ADDENDUM #1 – FEBRUARY 26, 2025

RE: CITY OF PORT ORFORD
American Legion Building Remodel
Project #18.27.3

FROM: HGE ARCHITECTS, Inc.
333 South 4th Street
Coos Bay, Oregon 97420
541-269-1166

M6.0

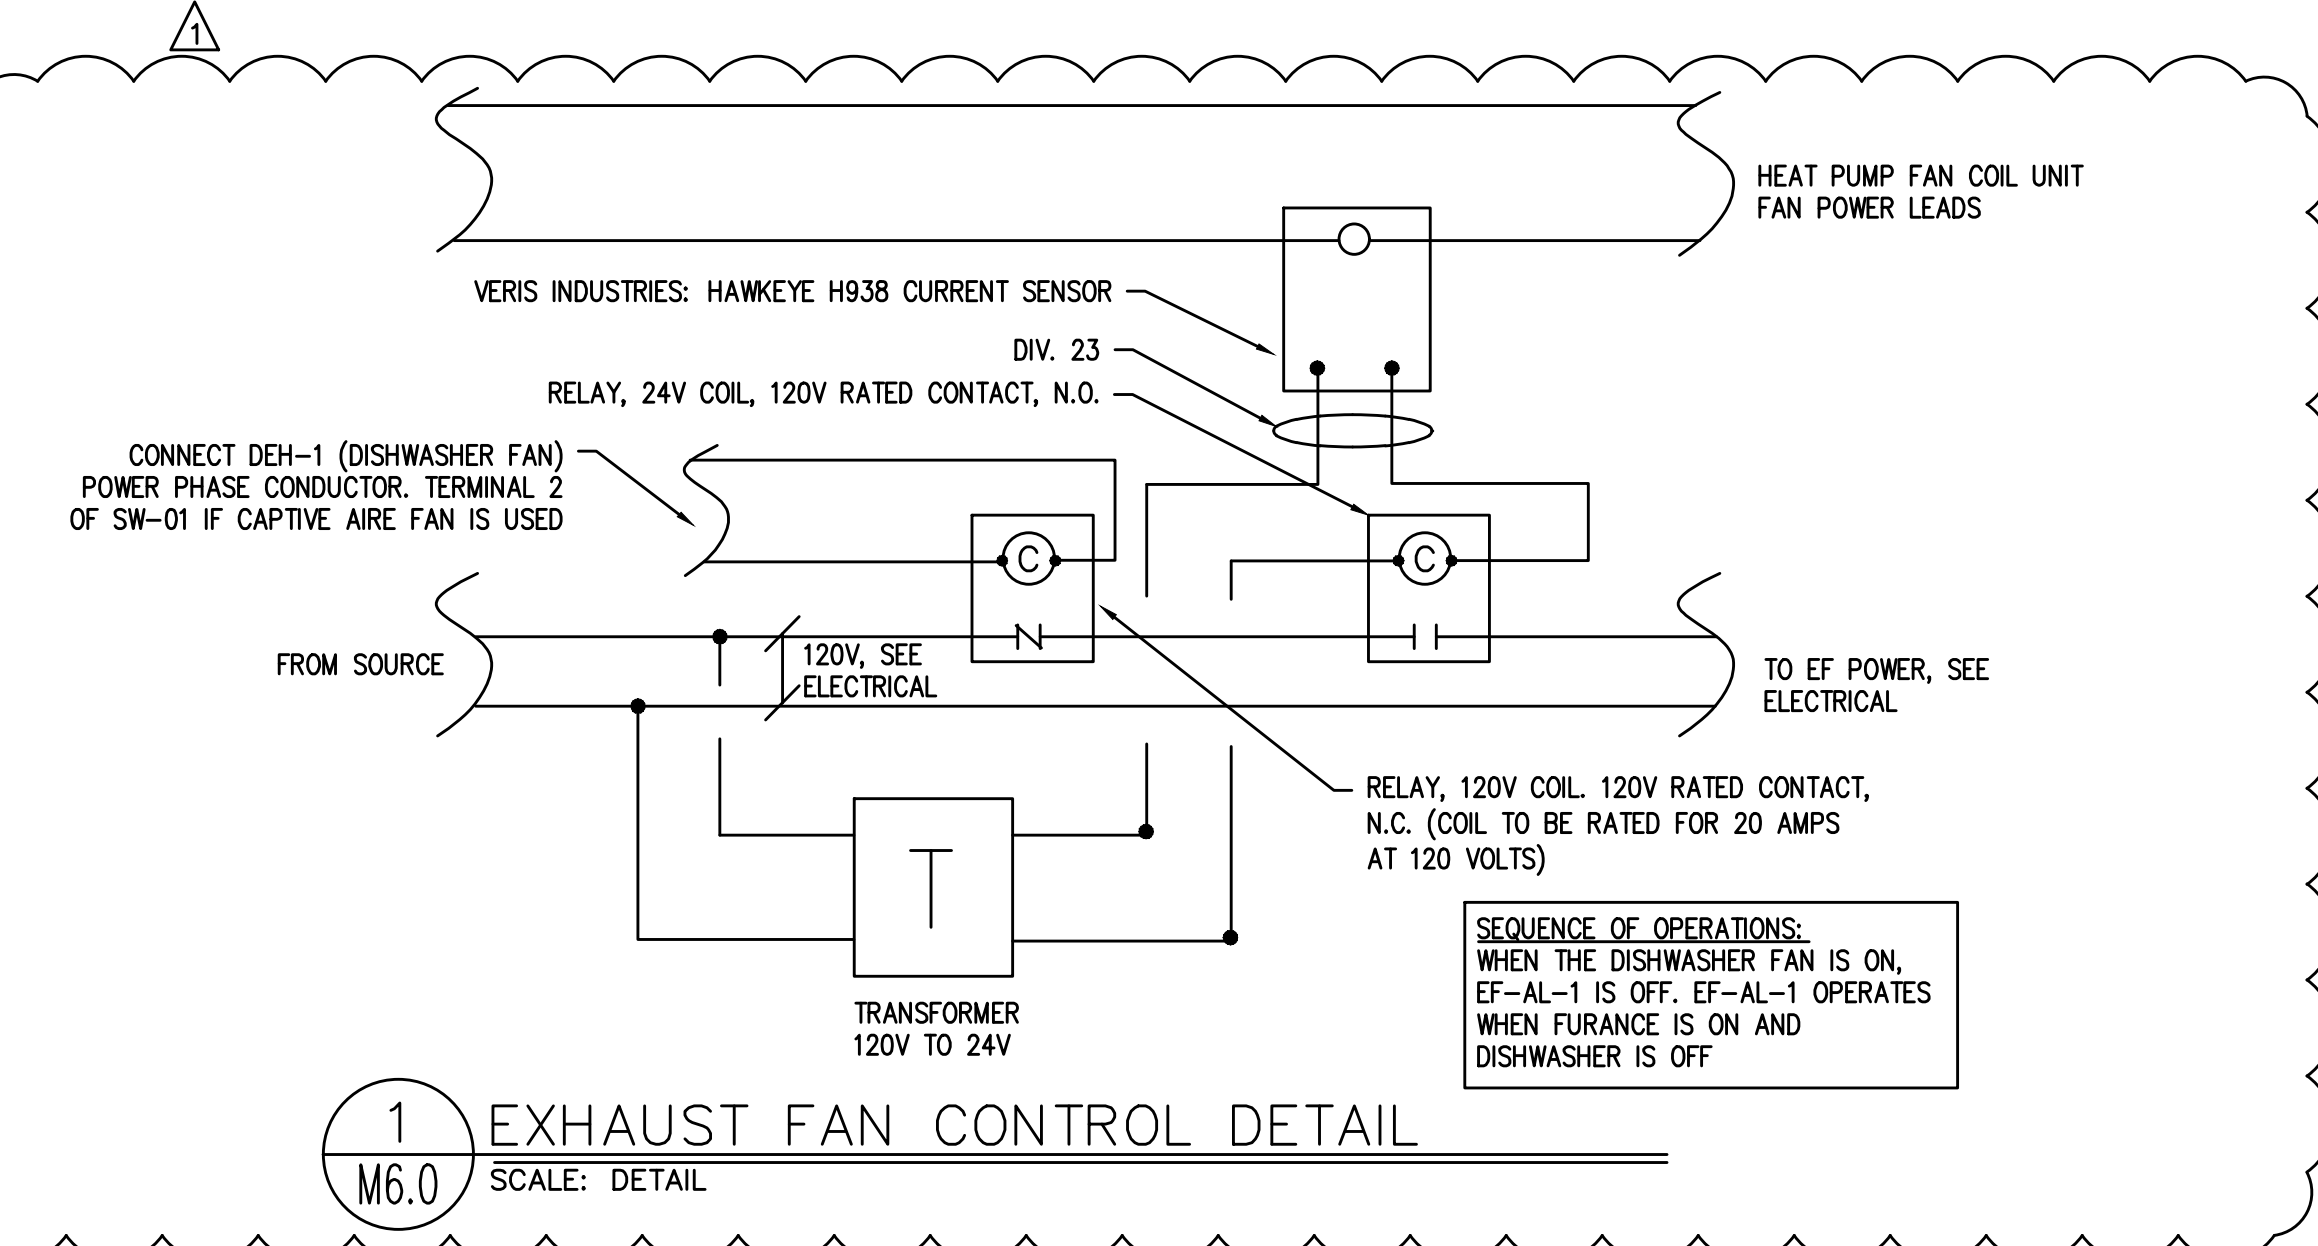
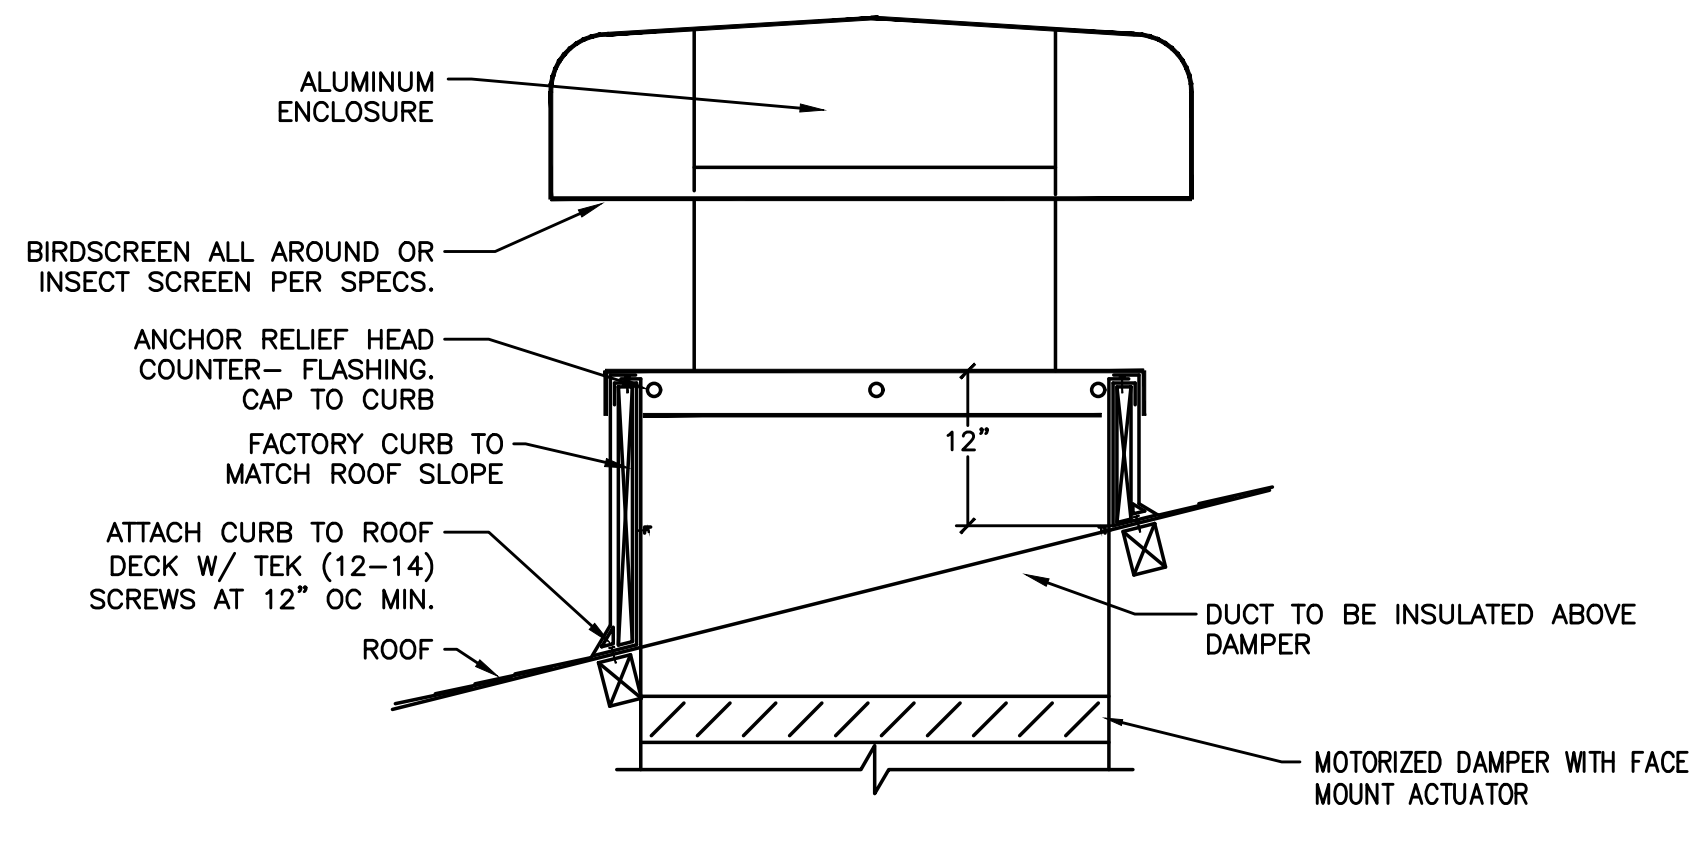
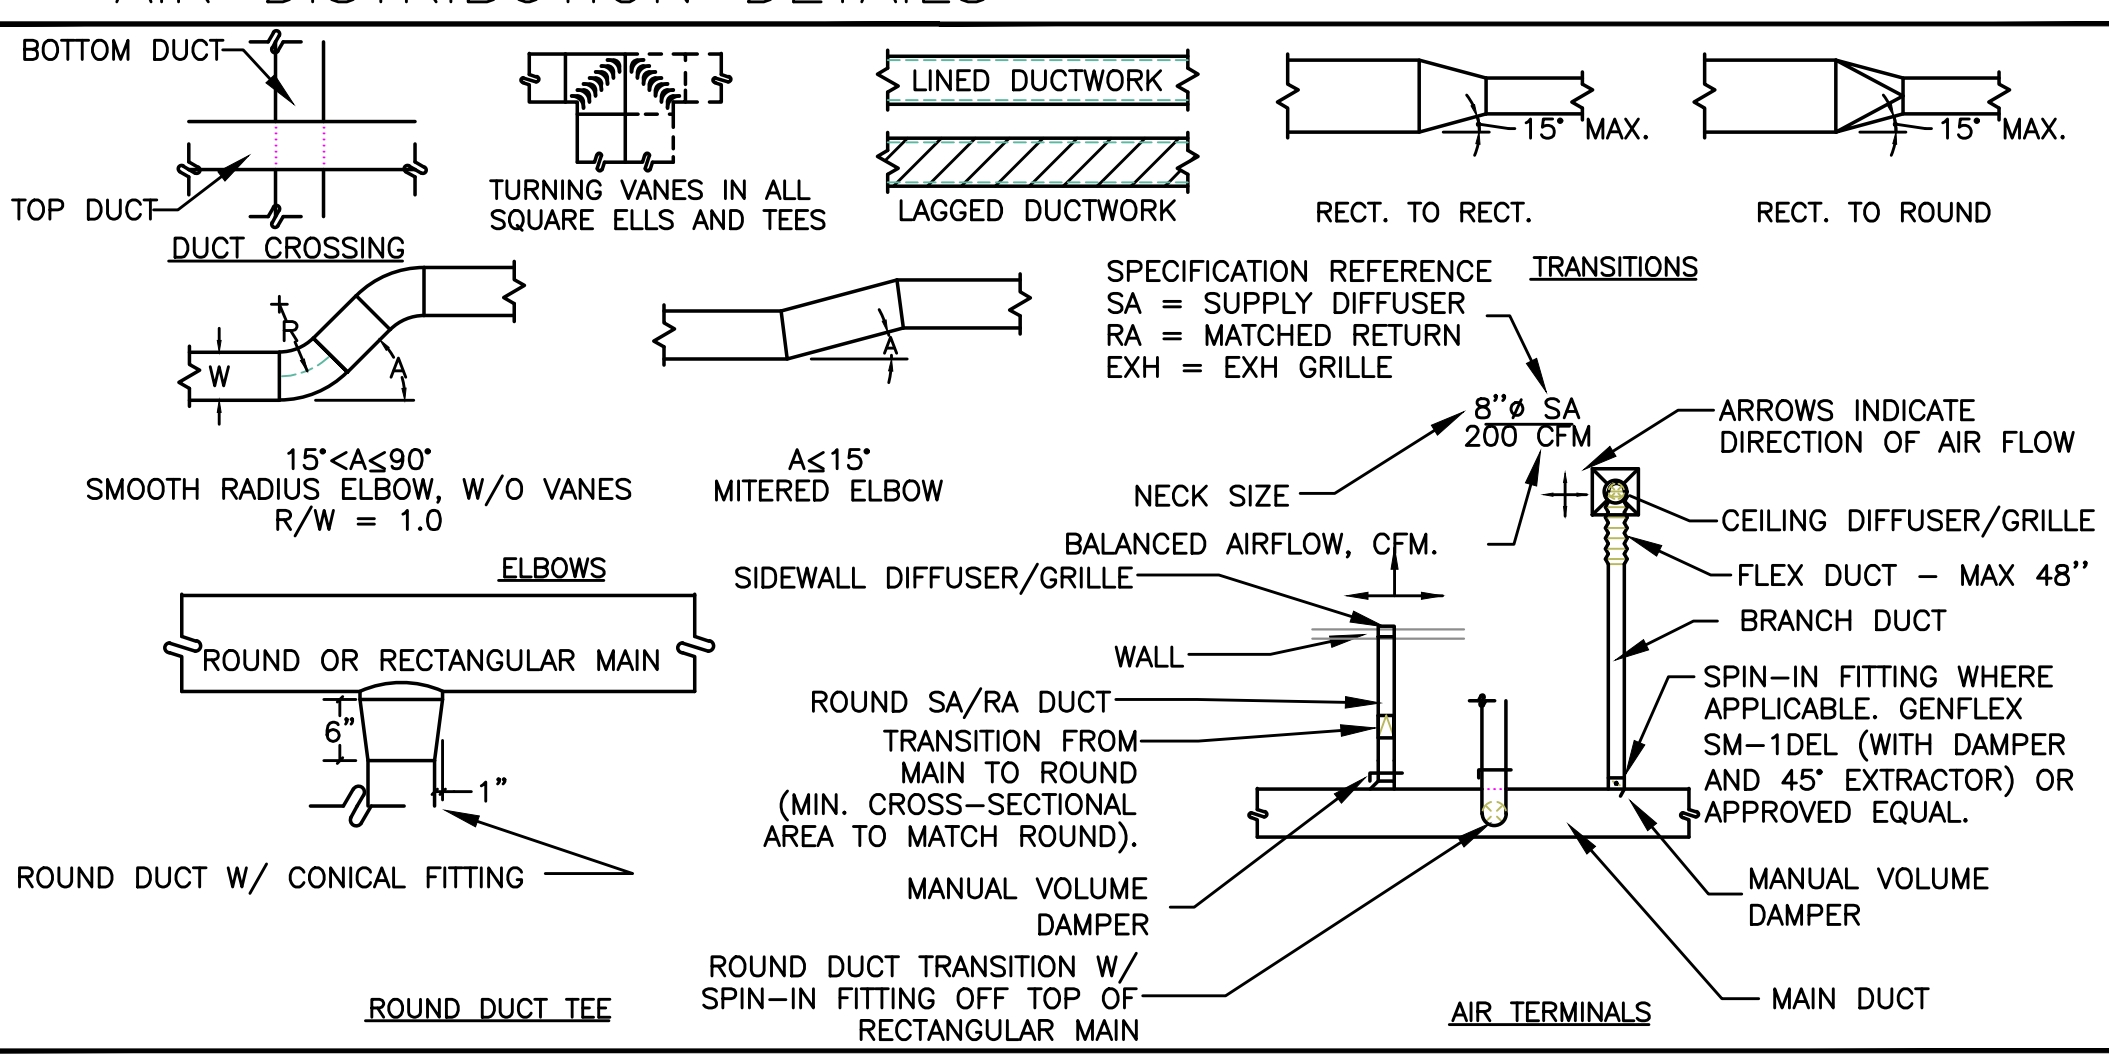
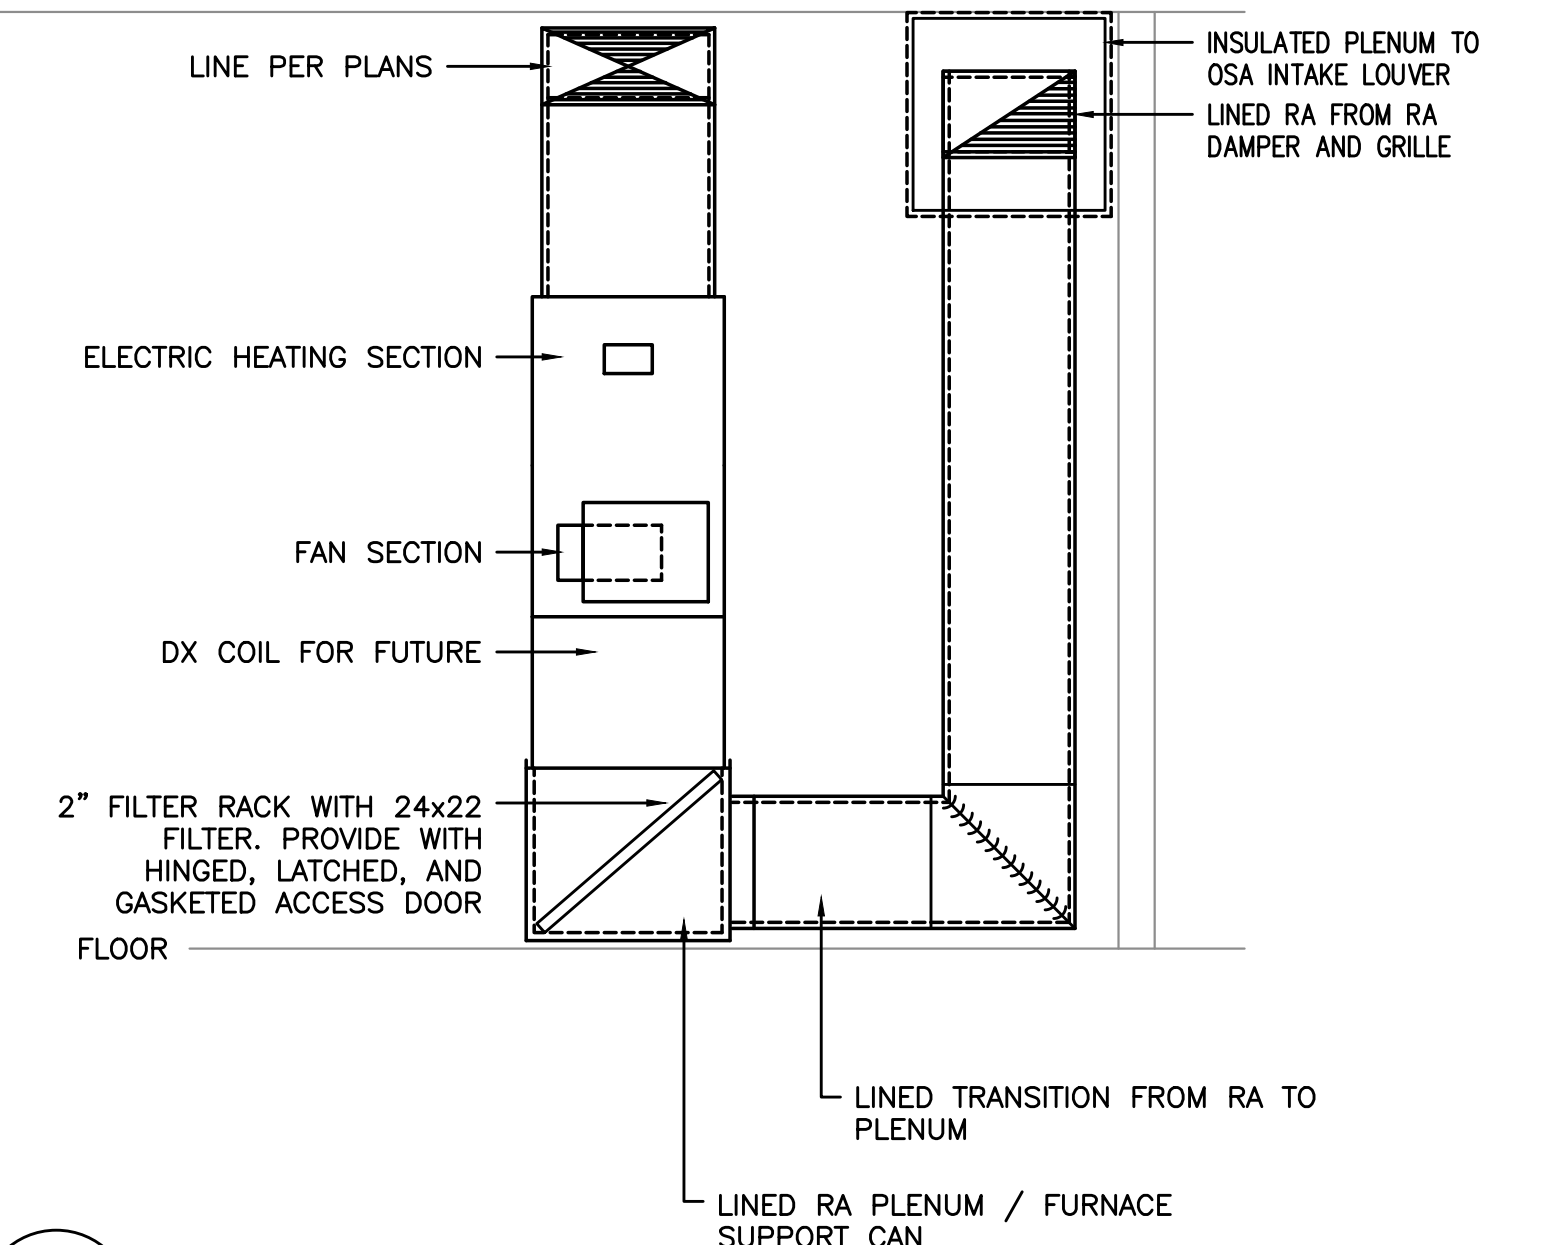
- 8. **Sheet M6.0 Mechanical Schedules and Details:** REPLACE with the attached revised Sheet in its entirety.
- 9. **Sheet E2.0 Electrical Plans Power & Lighting:** In Mechanical Equipment Schedule, ADD: "EF-1; Exhaust Fan; Kitchen: 100 W; 120 V; Ph 1; Notes 1, 3." Connect to circuit AL-37. See Mechanical plans for general location.
